# 1985 Corvette: Service News: Revised Differential Case Cross Pin Installation Procedure

**Model and Year:** 1985 Corvette

**Source:** Chevrolet Service News

**Date:** March/April 1985 - Volume 57 - Number 2

Fig. 4 — Installing Cross Pin

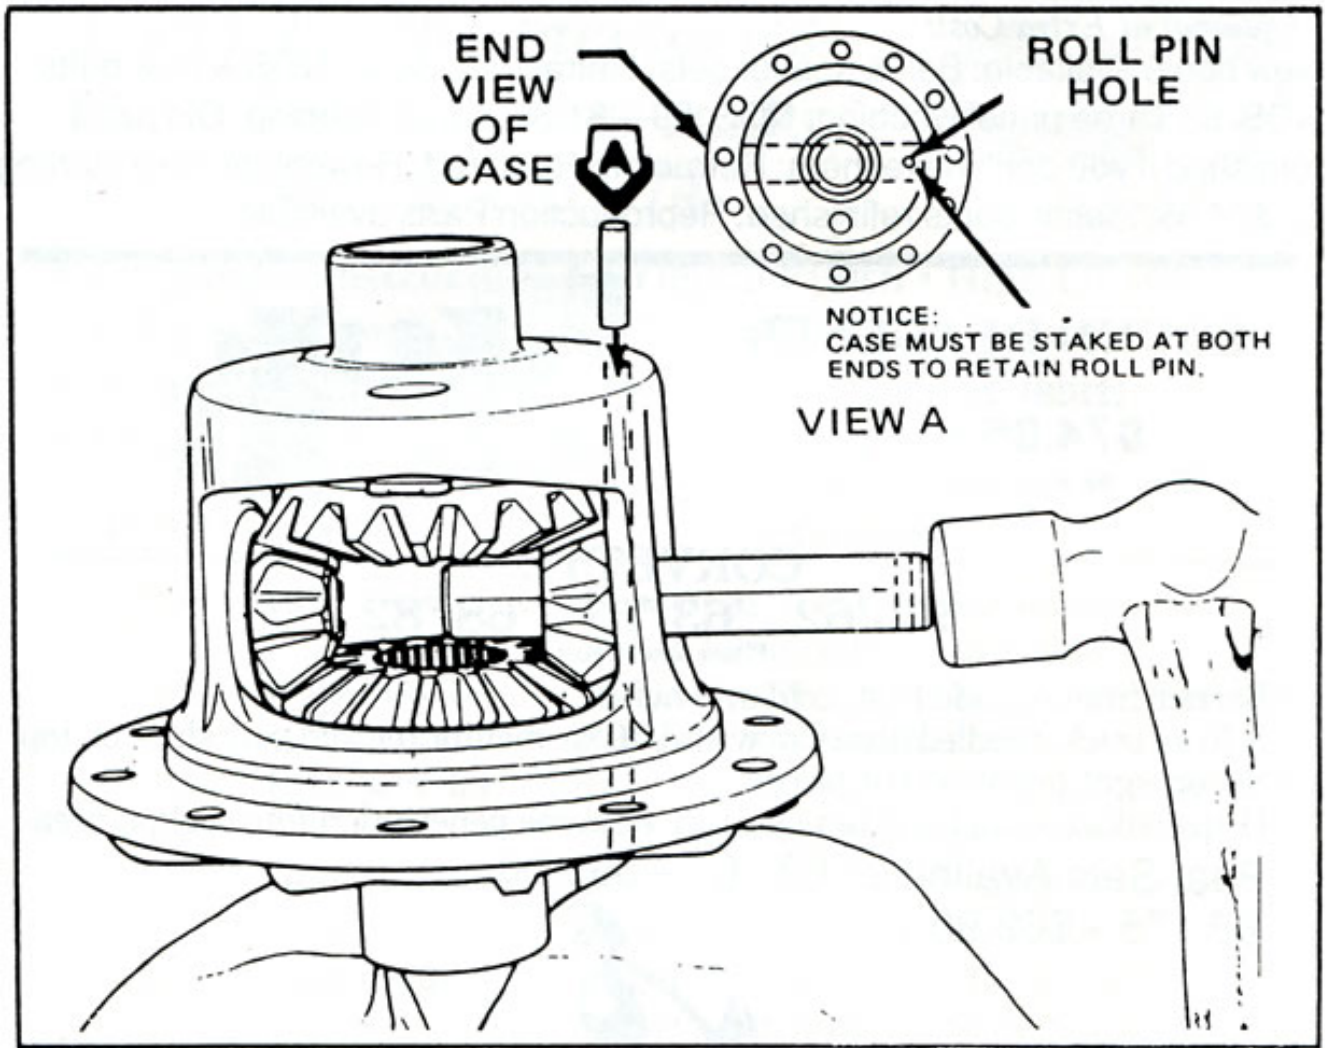
Figure 4B-39 shown on Page 4B-16 and step 10 shown on Page 4b-17 of the 1985 Corvette Shop Manual (ST-364-85) have been revised as indicated below. Fig. 4 replaces Figure 4B-39 presently shown in the Shop Manual.

10. Position the cross pin shaft in the case and drive in with a hammer. Be sure the retaining pin hole of the cross pin shaft is properly aligned to allow installation of the retaining pin. Install the retaining pin to the proper depth using a punch and stake in place at both ends of the case.
